IURA Request for Information/Clarifications – Harold's Holdings

Fig 1. Little Commons roof plan showing schematic solar design.

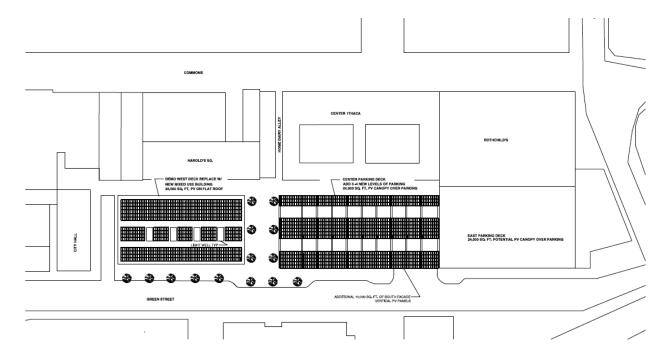
It appears that PV solar is proposed for both the residential roof and the parking garage. Please clarify the developer's role in the proposed solar PV arrays.

Is the cost of the PV solar included in the financing plan? If not, please provide a revised financing plan that includes the PV solar array on the residential building.

If a power purchase agreement is proposed for the parking garage PV array, please estimate the per kW rate, term and annual increase required to be charged to cover the cost to install a PV array on a canopy system over the parking garage top deck.

An integral part of the overall concept for Little Commons is to provide a solar micro grid which will offset the peak energy demands of the proposed mixed use building as well as potentially provide solar charging stations for the parking deck. An opportunity exists to utilize a solar array atop and down the south facade of the center deck and adjacent proposed mixed-use building to facilitate the conversion of the site and beyond to a distributed micro grid power source serving the Green Street block (Fig. 1). Synergies with emerging technologies and integrated approaches offer a real potential for this project in terms of a resilient and regenerative model for downtown Ithaca.

We are anticipating that there will be a power purchase agreement with the onsite building in the neighborhood of \$0.09-\$0.12/kWh range for 25 years with a 2% escalator. Our system will include a solar array on top of the center deck providing 300 kW as well as a solar array on the roof of the mixed use building providing an additional 200 kW for a combined total of 500 kW.
